DYNASYS TECHNICAL SERVICE BULLETIN

TSB – 073016-1

Re: Dynasys SL Series APU units

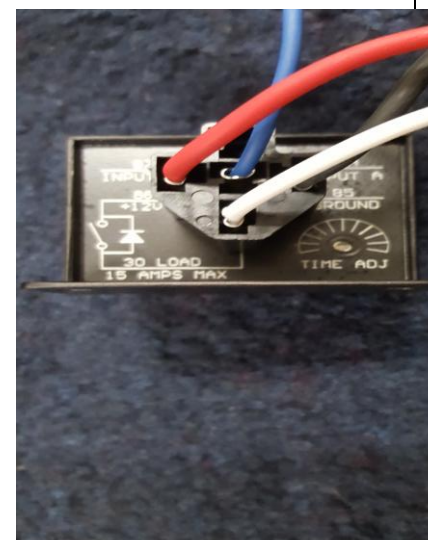
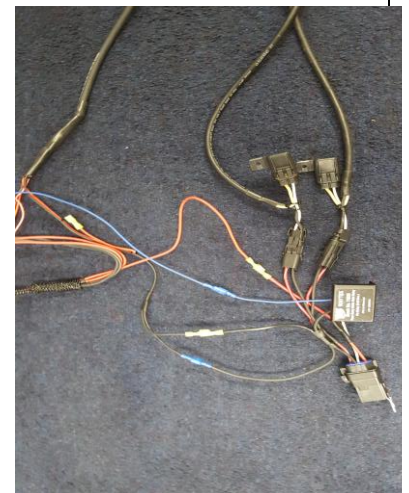
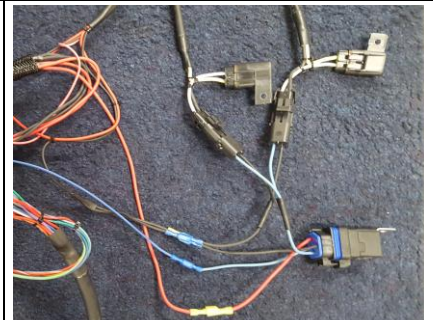
Notice:
New install to approximately 1000 hours of service life the APU engine may experience crank but no start or start then stall when the A/C compressor is engaged.

Remedy:
The following documentation details the installation of the Delay Timer . This remedy needs to be performed for all units while being installed, when a customer has the complaint of no start or stalling when the compressor engages, and when units directed to a dealer as result of this TSB.

1. Locate the A/C Compressor Relay near the HVAC Box.
 2. Disconnect the Red, Blue, and two Black wires from the associated harnesses as well as the two 2 pin connectors for the Condenser Fan and A/C Compressor from their associated harnesses. Discard the Compressor Relay.
 3. Attach the A/C Compressor Relay with Timer to the same color connections as the original set.
 4. Adjust Timer to the maximum of 2 minutes by gently turning the dial clockwise to the stop.
- Test and return to service.
